**Globemaster Corridor Specific Plan
Program EIR/EIS (SCH No. 2018091021)
EIR-03-17**

1 Introduction to the Final PEIR/PEIS

This chapter of the Final Program Environmental Impact Report (PEIR) and Program Environmental Impact Statement (PEIS) includes a copy of all comment letters that were submitted during the public review period for the Draft PEIR/PEIS (State Clearinghouse No. 2018091021) for the proposed Globemaster Corridor Specific Plan (GCSP; Proposed Project), along with responses to comments in accordance with California Environmental Quality Act (CEQA) Guidelines Section 15088 and National Environmental Protection Act. The 45-day public review period for the Draft PEIR/PEIS began on August 3, 2020 and ended on September 17, 2020.

FIGURE 2-2

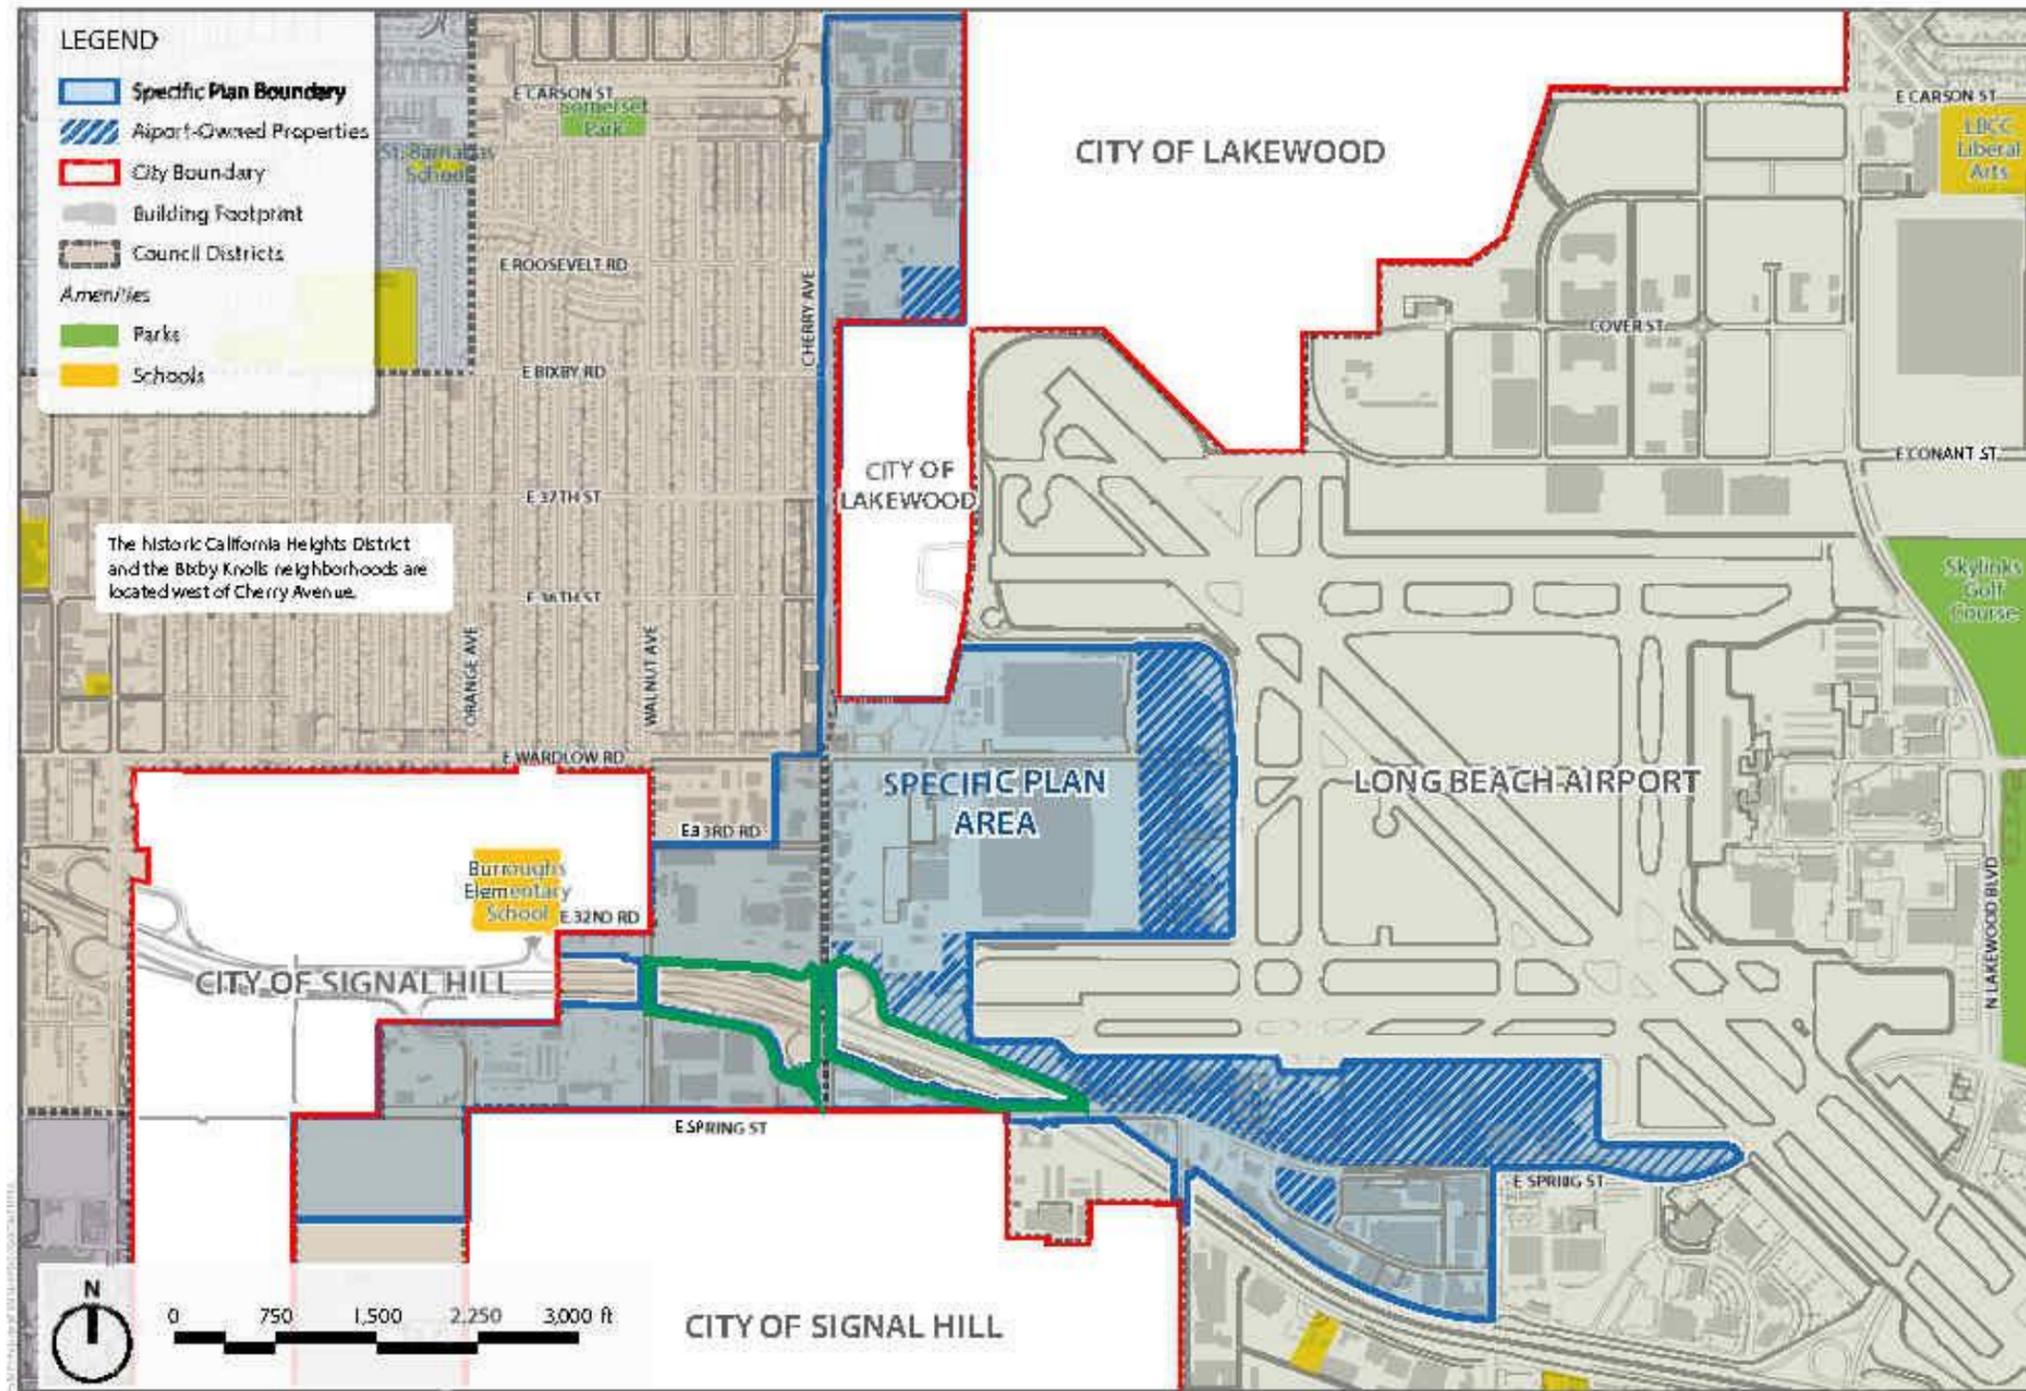
- Figure 2-2 Local Context: An Airport property is not identified in this exhibit. Assessor Parcel Number 7149-010-902 on the south side of Spring Street between Airport Way and Airport Lane is Airport-owned. Please note that this omission appears to only occur on Figure 2-2.

- 5-2** This comment is related to Figure 2-2, Local Context, in Chapter 2, Project Description, of the Draft Program Environmental Impact Report/Program Environmental Impact Statement (PEIR/PEIS). The commenter notes the airport property is not defined in this exhibit. Figure 2-2, Local Context, has been revised to include a portion of airport-owned property located south of Spring Street between Airport Way and Airport Lane that was not identified. Refer to Chapter 3, Changes to the Draft PEIR/PEIS, of this Final PEIR/PEIS.

Figure 2-2, Local Context, has been revised to include a portion of Airport-Owned Property located south of Spring Street between Airport Way and Airport Lane that was not identified in the Draft PEIR/PEIS. See the revised figure

FIGURE 2-9
 Example Development in Business Park District
 Globemaster Corridor Specific Plan Draft PEIR/PEIS

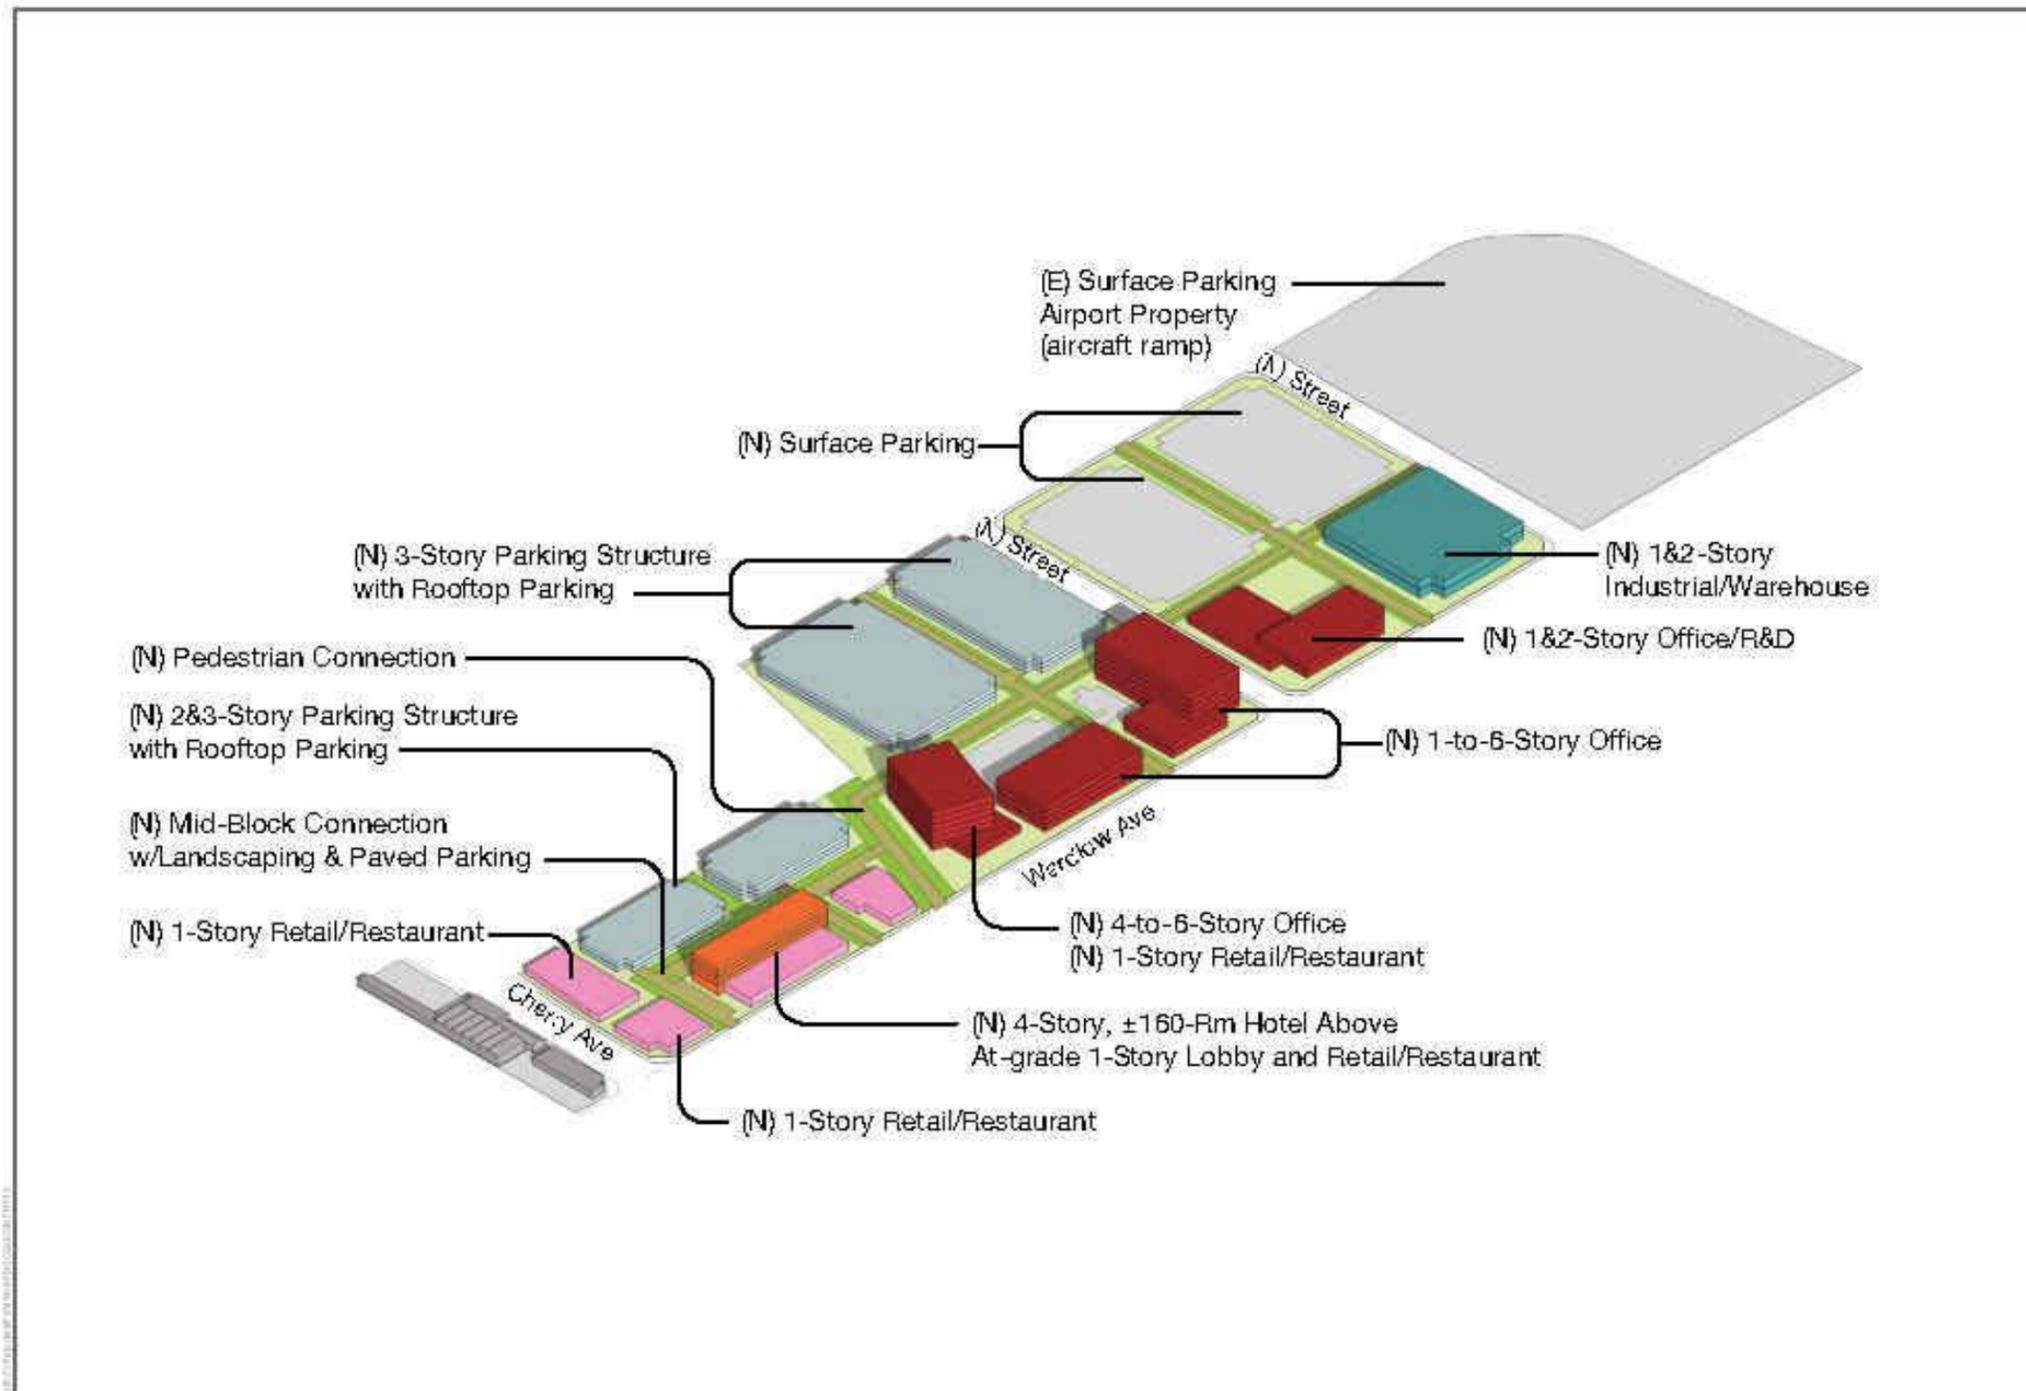
5-4
- Figure 2-8 Example Development in Business Park District: Area (E), Surface Parking, is Airport restricted property for aviation development. It would not be available to support non-aeronautical uses within the Plan Area.

5-5 This comment is related to Figure 2-8, Example Development in Business Park District, in Chapter 2 of the Draft PEIR/PEIS, noting Area E surface parking. The commenter states that this area is airport restricted for aviation development and it would not be available to support non-aeronautical uses. The commenter is correct in that the referenced area is marked as existing “E” surface parking and does not show new potential development because it is within the adjacent Airport District and, as previously mentioned, is reserved for property that is part of the designated airfield of the Long Beach Airport, and adjacent properties under Airport control. To clarify, this section of the figure has been revised to indicate “Airport Property (aircraft ramp)” underneath “(E) Surface Parking”. See the revision in Chapter 3, Changes to the Draft PEIR/PEIS, in this Final PEIR/PEIS.

Figure 2-8, Example Development in Business Park District, has been revised based on a comment provided by the Long Beach Airport to clarify that the area labeled as existing surface parking notes that this area is under Airport control. See the revised figure attached to the end of this chapter of the Final PEIR/PEIS. The proposed revision does not alter the analysis or conclusions presented in the Draft PEIR/PEIS.

FIGURE 3.11-3
Existing Year 2018 Truck Routes
Globemaster Corridor Specific Plan Draft PEIR/PEIS

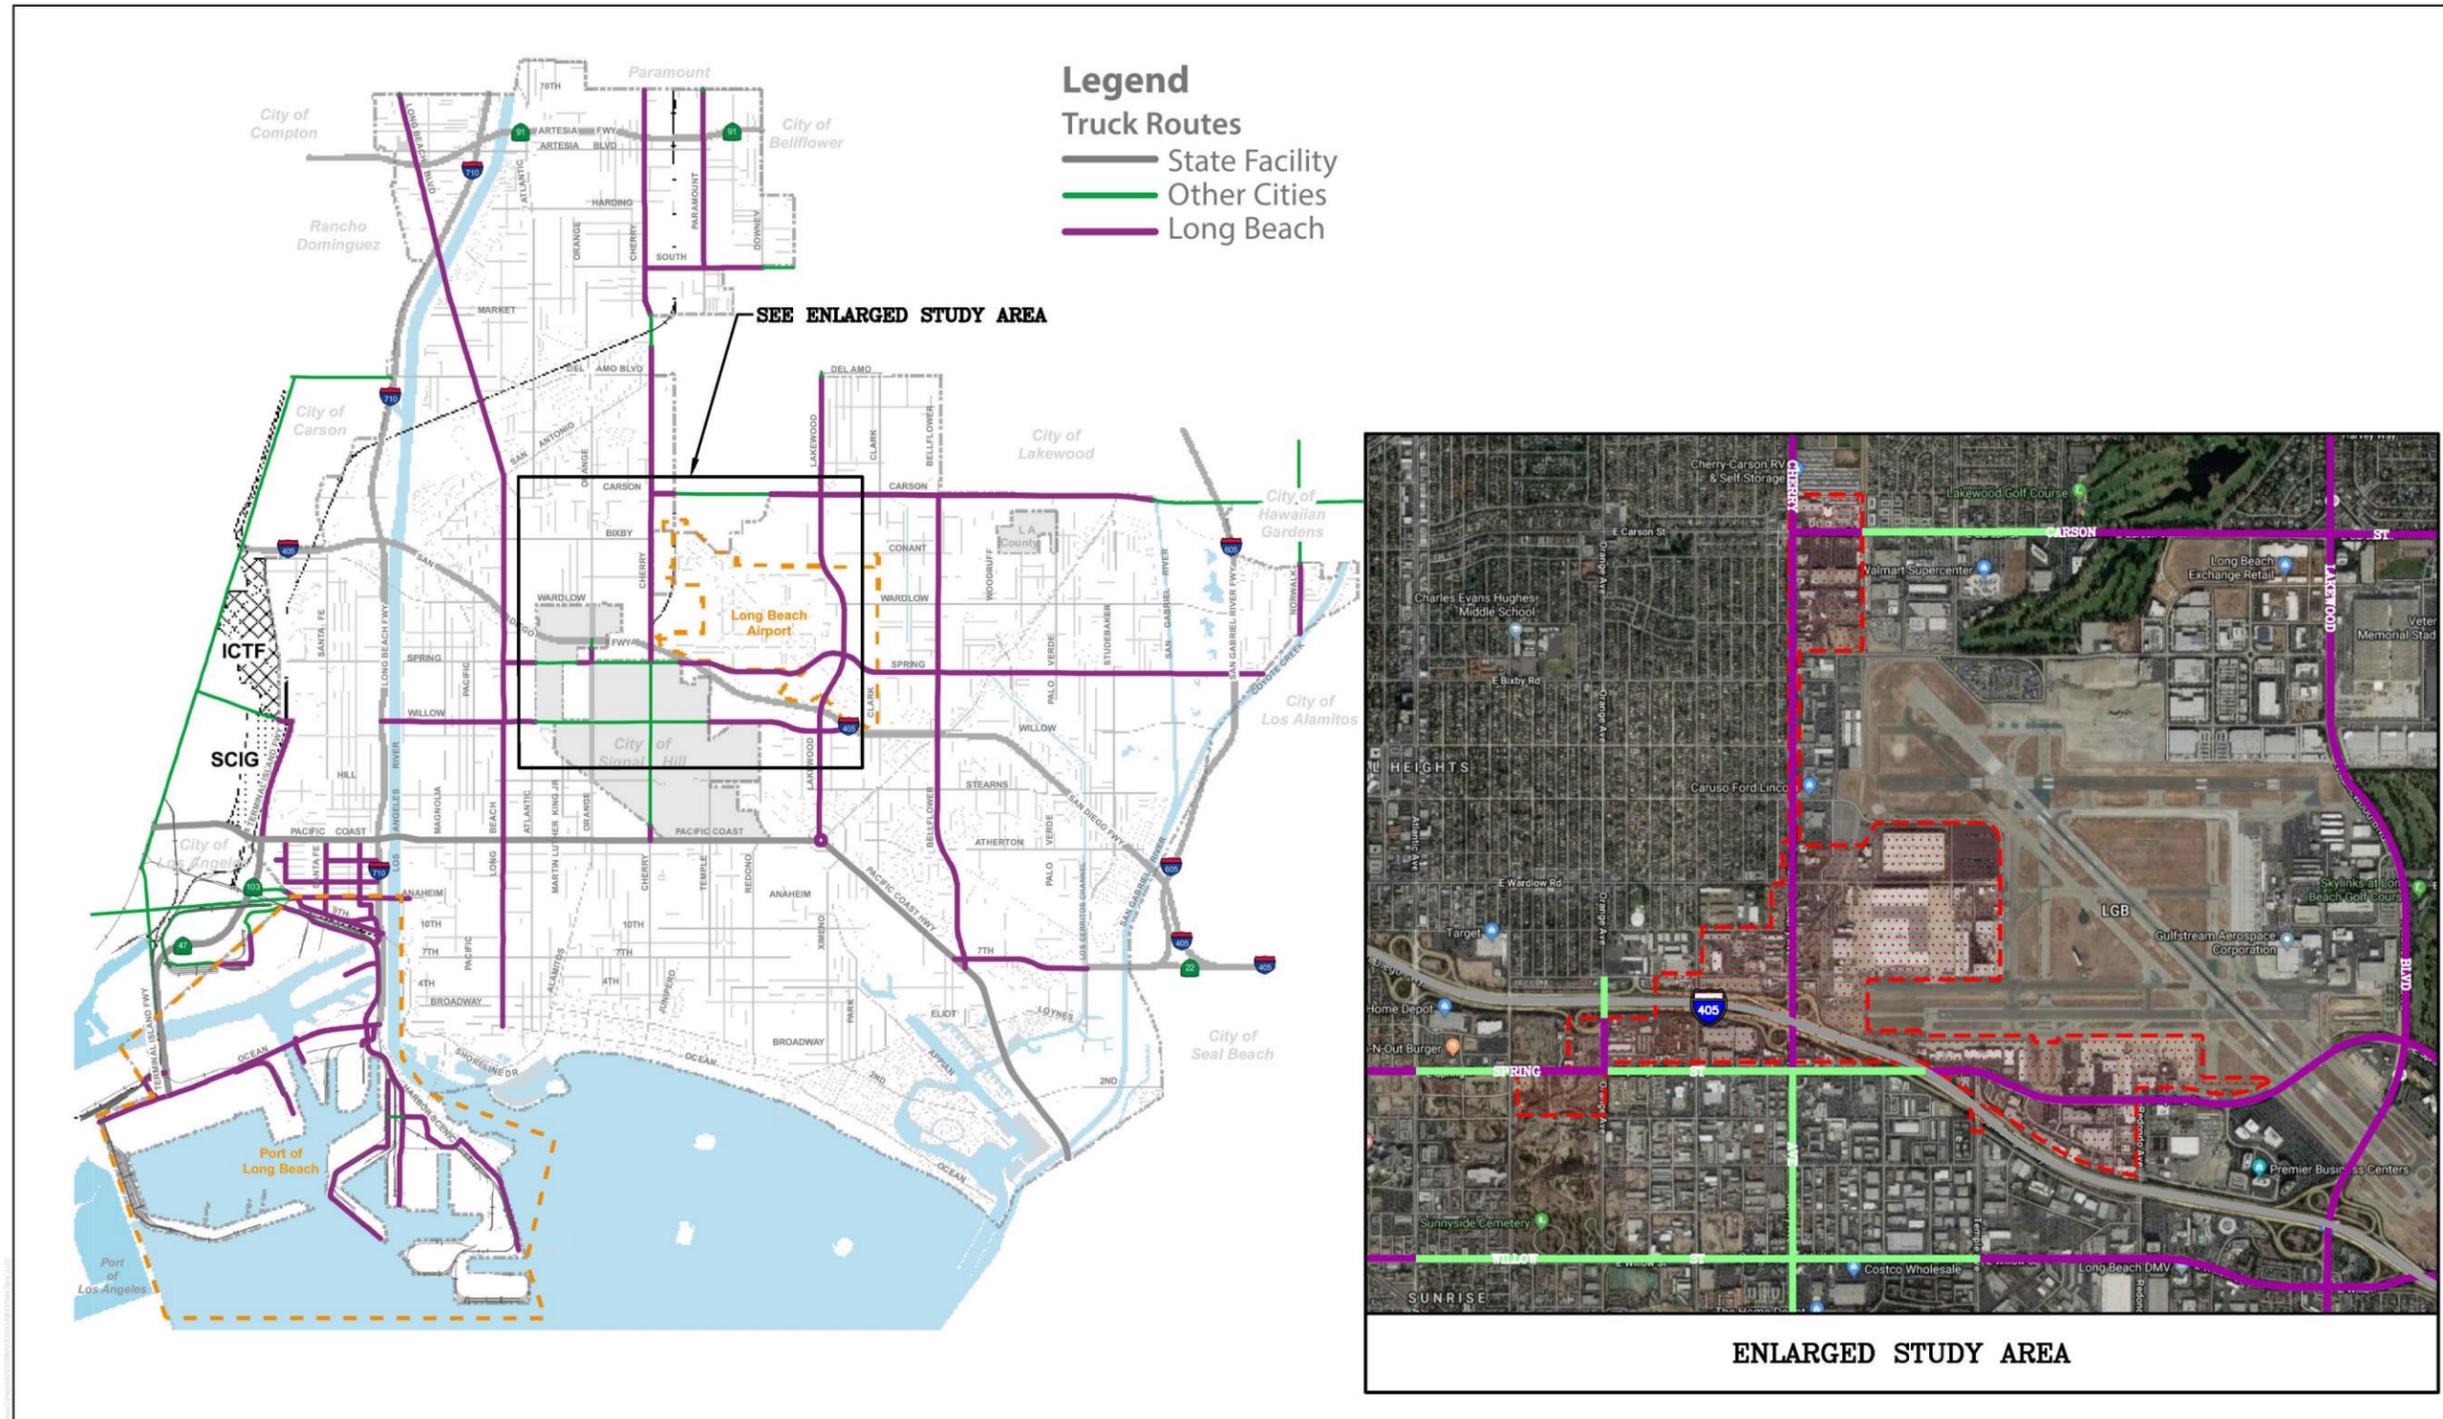
6-8 The comment states that Orange Avenue (from Hill Street to Spring Street and from 32nd Street to Wardlow Road) is not a Truck Route within the City of Signal Hill. Figure 3.11-3, Existing Year 2018 Truck Routes, has been revised in response to this comment. See Chapter 3, Changes to the Draft PEIR/PEIS, of this Final PEIR/PEIS. This revision does not affect any of the evaluation concerning truck

Figure 3.11-3, Existing Year 2018 Truck Routes, has been revised to remove Orange Avenue as a truck route in the City of Signal Hill. See the revised figure attached to the end of this chapter of the Final PEIR/PEIS. The proposed revision does not alter the analysis or conclusions presented in the Draft PEIR/PEIS.
